STAFF RECOMMENDATION
1514 Ferguson Avenue
February 19, 2020

Application: New Construction-Addition
District: Belmont-Hillsboro Neighborhood Conservation Zoning Overlay
Council District: 18
Base Zoning: R8
Map and Parcel Number: 11708012500
Applicant: Lauren Williams
Project Lead: Melissa Baldock, Melissa.baldock@nashville.gov

SITE PLAN
"PROPOSED BUILDING ADDITION"
 FERGUSON AVE DEVELOPMENT, LLC PROPERTY
 1514 FERGUSON AVENUE
 CITY OF NASHVILLE, TENNESSEE
 DAVIDSON COUNTY
 18TH COUNCILMANIC DISTRICT
 SCALE: 1"=20'
 DATE: FEBRUARY 7, 2020

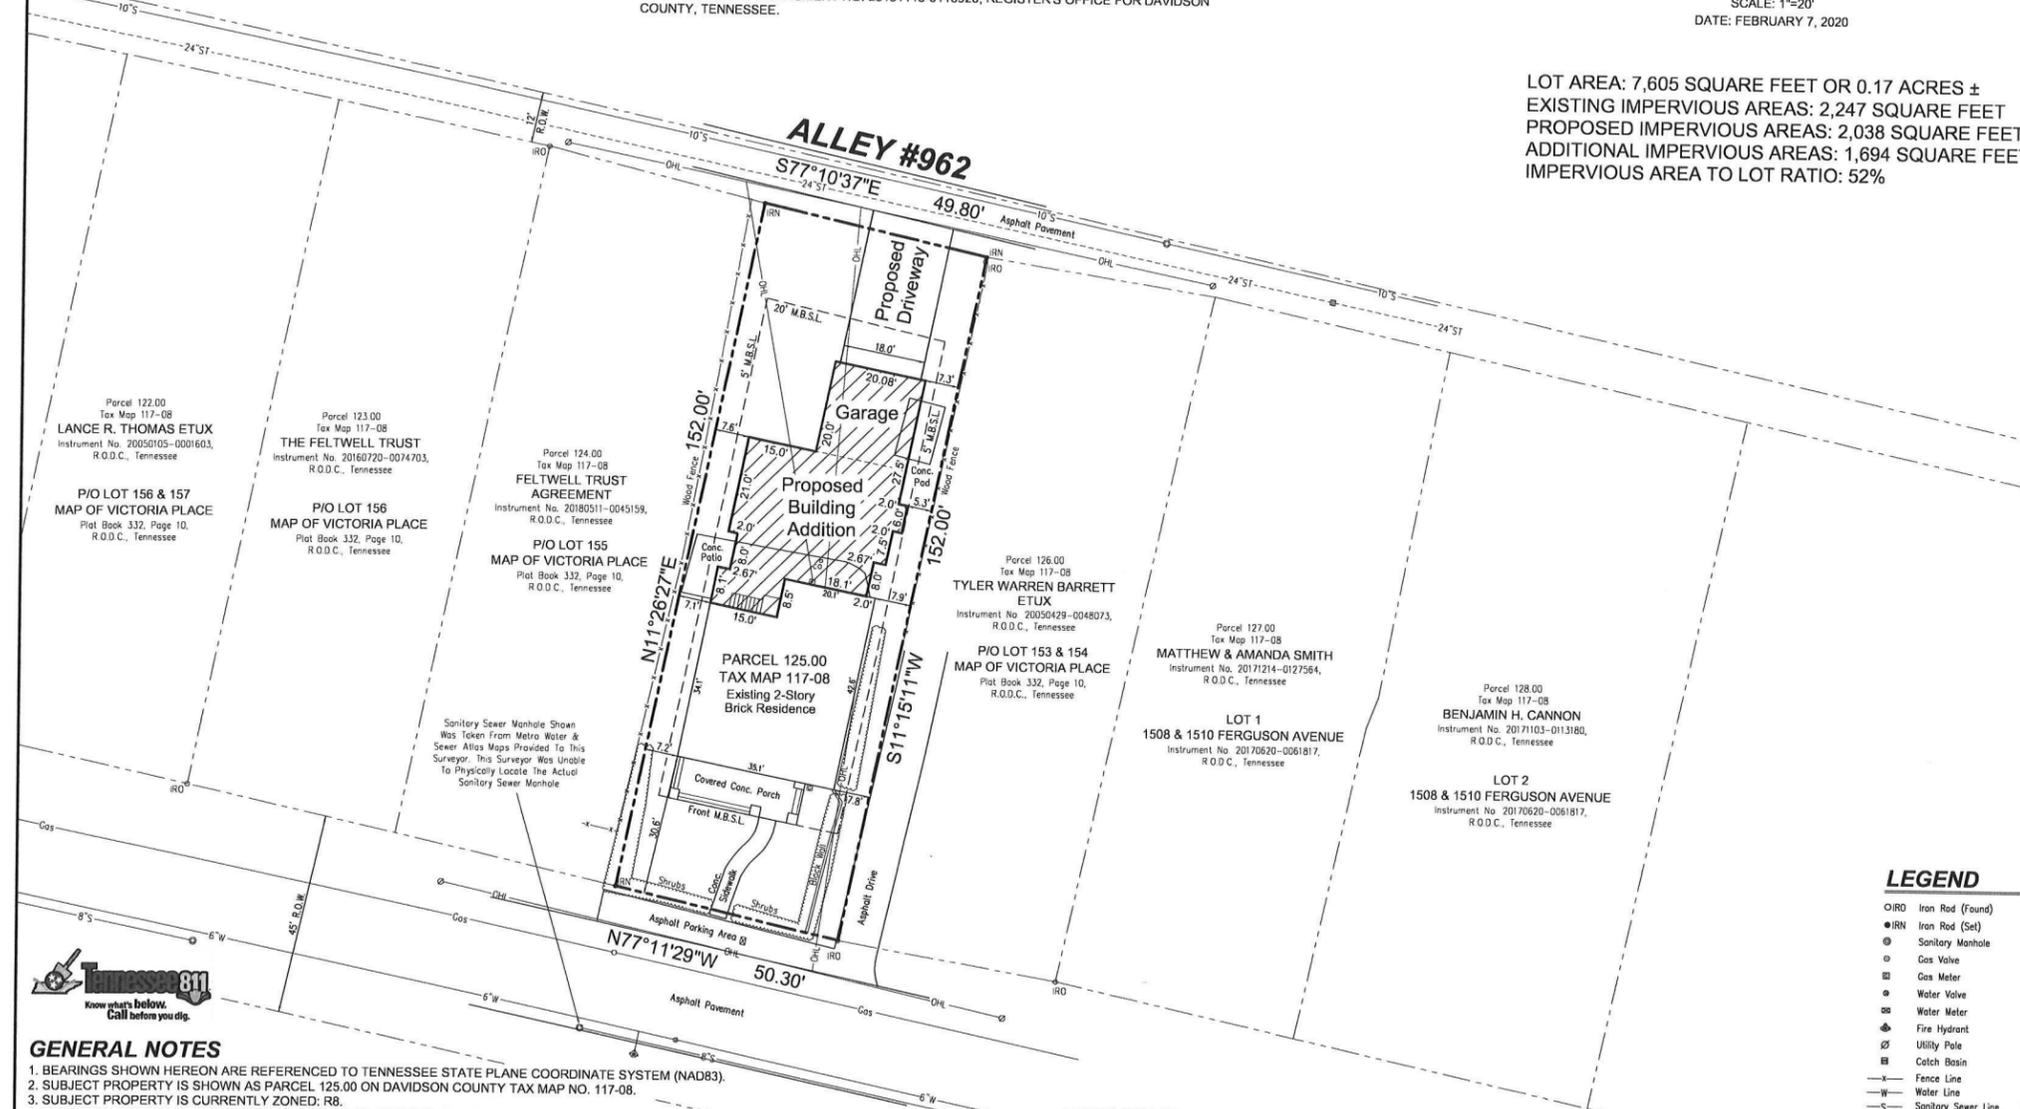
Setback & Rhythm of Spacing: The addition meets all base zoning setbacks. It will be a minimum of seven feet, three inches (7'3") from the right-side property line and seven feet, six inches (7'6") from the left side property line. It will be approximately thirty feet (30') from the rear property line. Because the addition is no wider than the historic house, it will not affect the rhythm of spacing of houses along Ferguson Avenue.

Staff finds that the proposed addition meets Sections II.B.1.c. and II.B.2. of the design guidelines.

Original House Dims
 Scale: 1/4" = 1'-0"
1514 Ferguson Ave.
Nashville, Tennessee

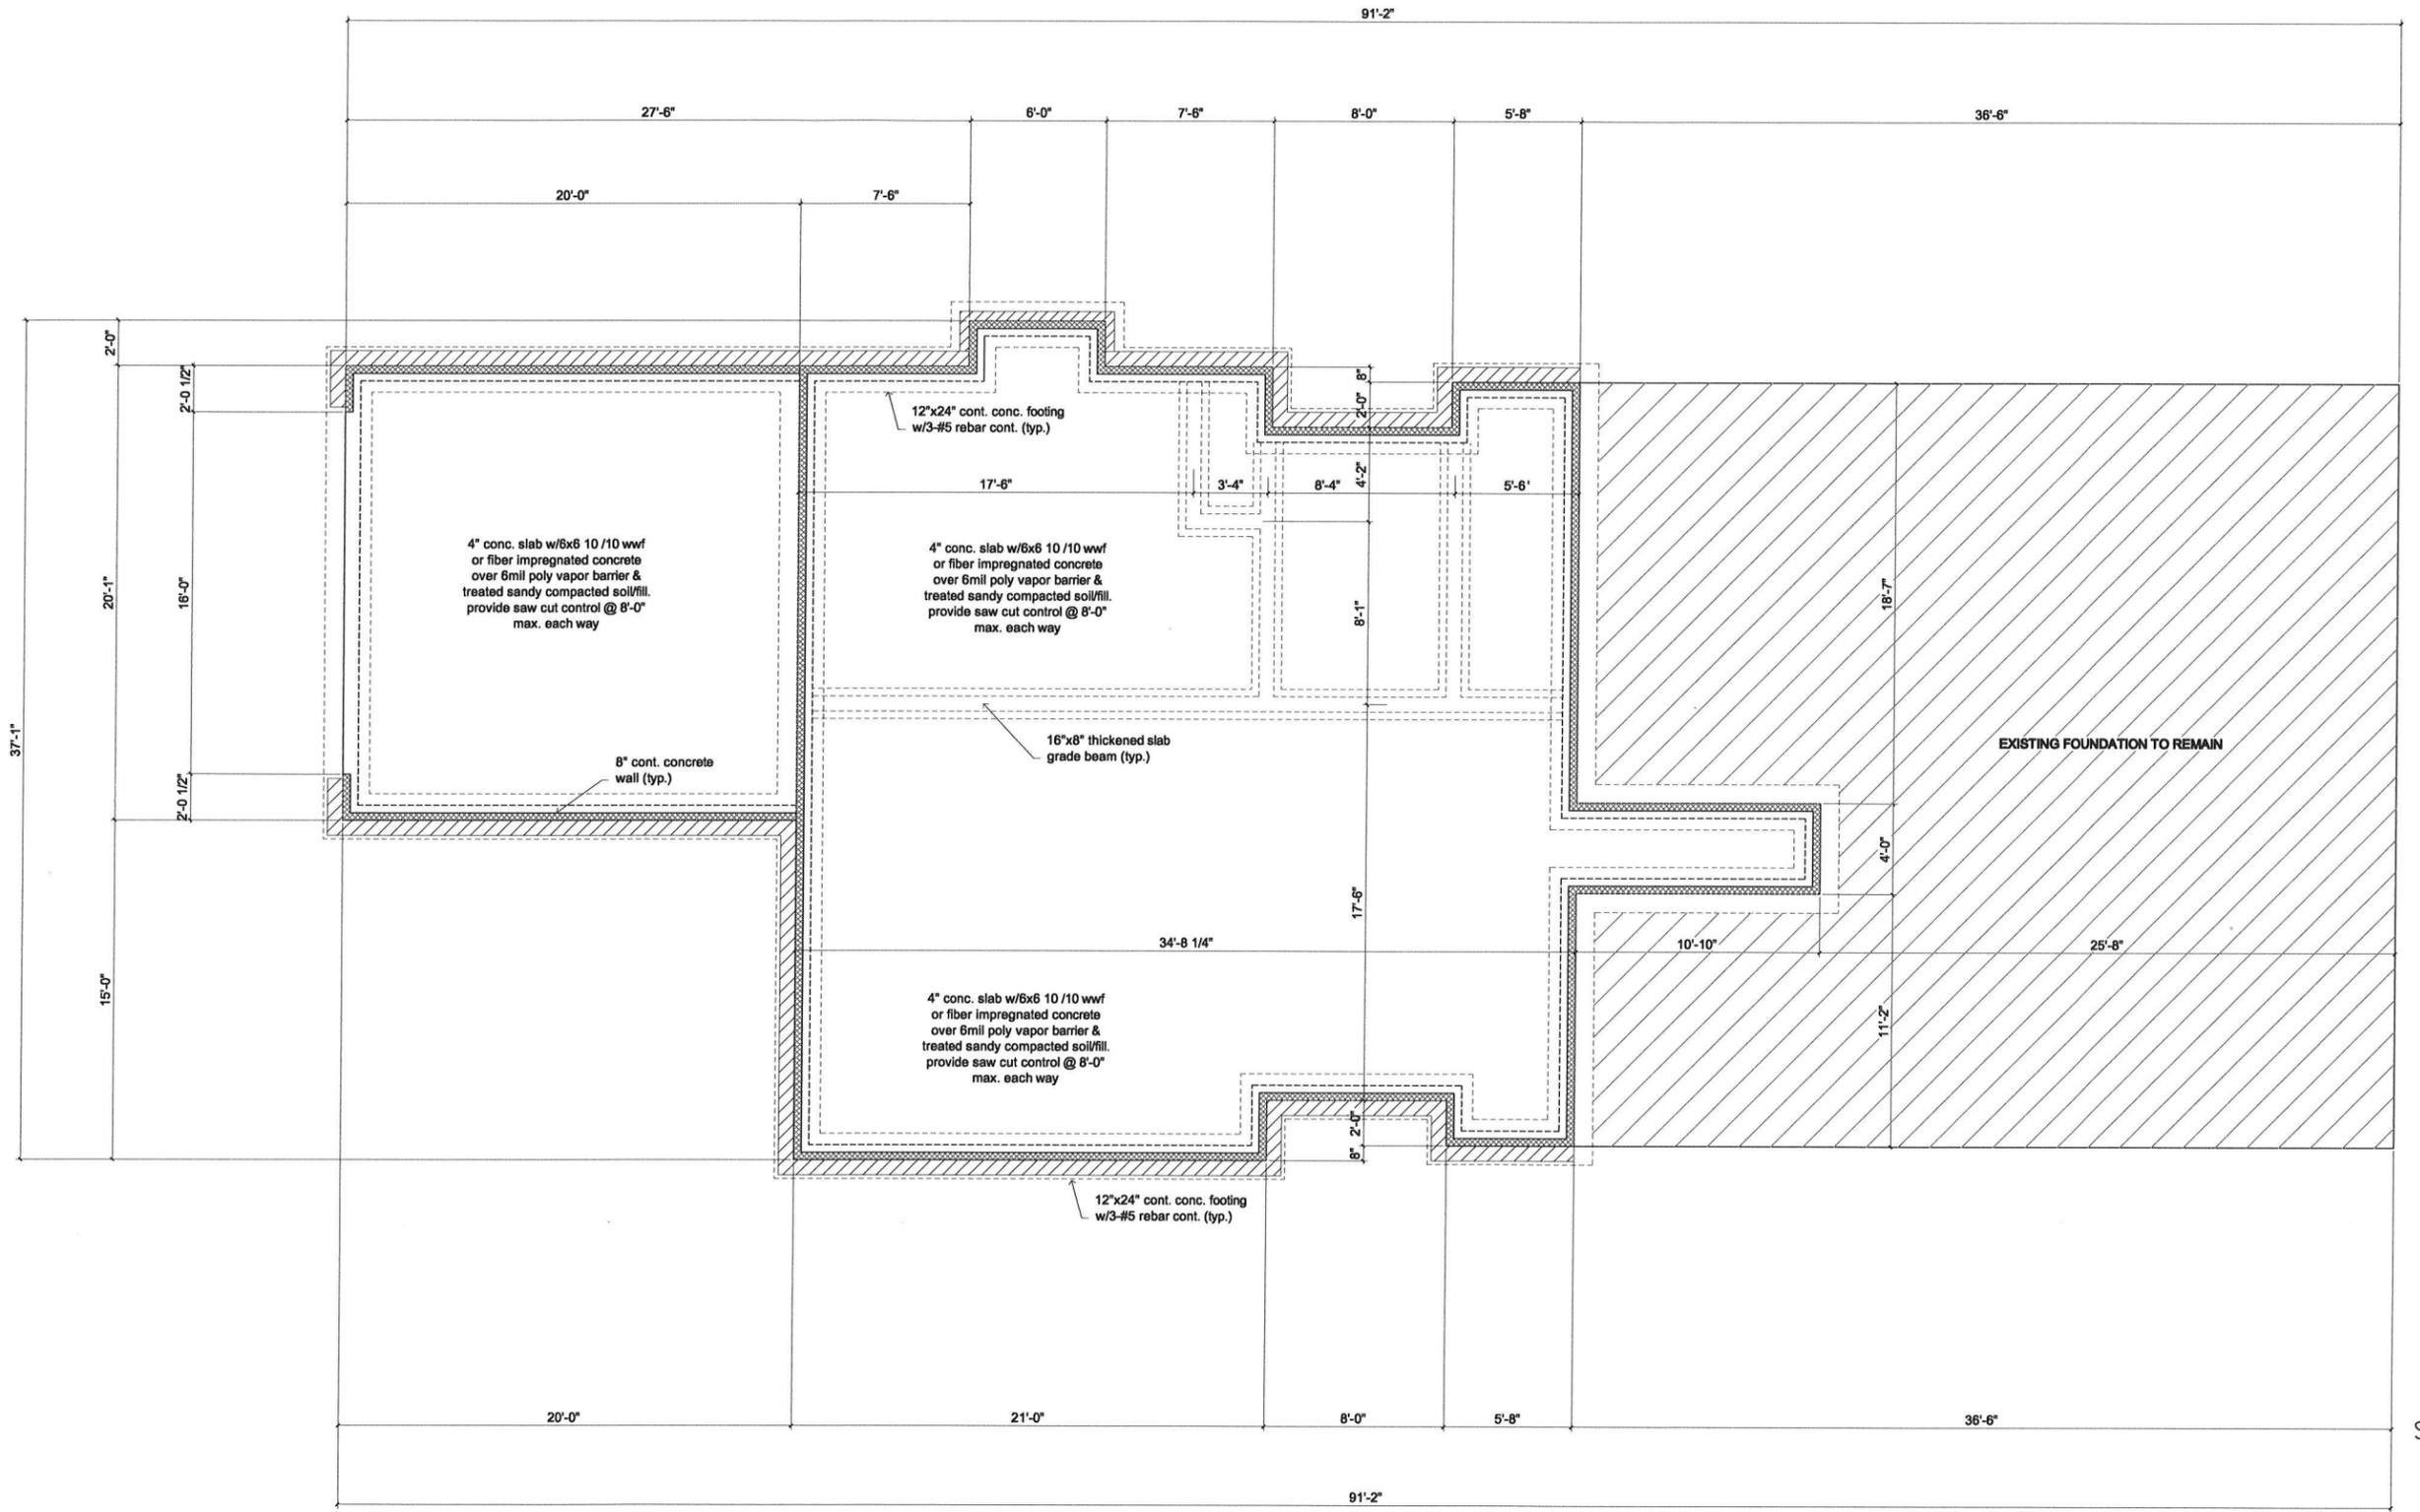
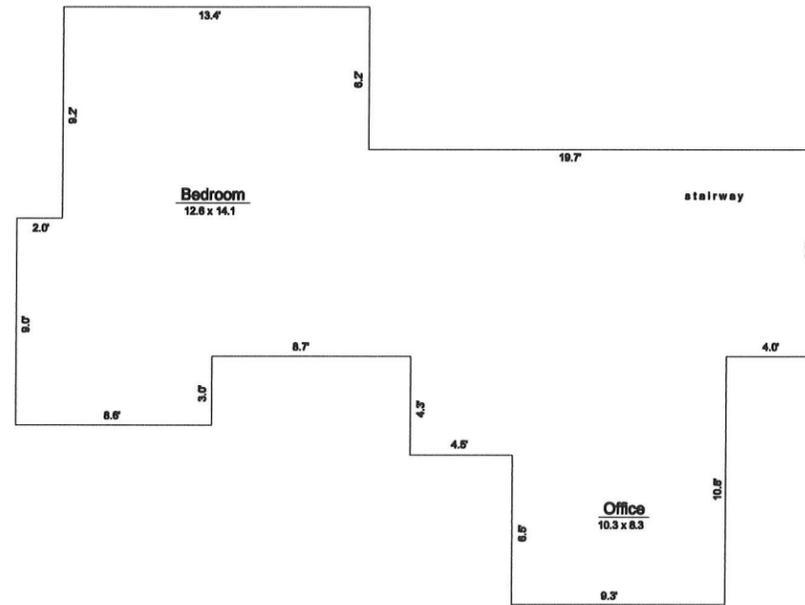
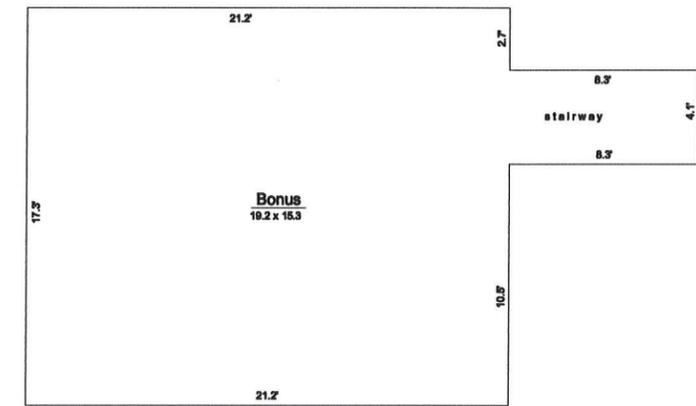
Height & Scale: The proposed addition includes a two-foot (2') ridge raise that is inset two feet (2') on each side, which meets the design guidelines. The addition is therefore two feet (2') taller than the historic house, but its ridge and foundation heights match those of the historic house. Because of the steep slope of the lot from front to back, the addition includes a basement-level garage, facing the rear, which meets the design guidelines.

The addition is inset two feet, eight inches (2'8") at the back corners of the house on the ground floor for a depth of eight feet (8'). After the inset, on the ground floor, the addition steps back out to line up with the side walls of the historic house. The addition is inset two feet (2') for its entire depth on the second story. The addition will add approximately one thousand, three hundred and eighty-one square feet (1,381) to the house, which has a footprint of approximately one thousand, six hundred, and seventy-two square feet (1672 sq. ft.).

Staff finds that the proposed addition meets Sections II.B.1.a., II.B.1.b., and II.B.2. of the design guidelines.
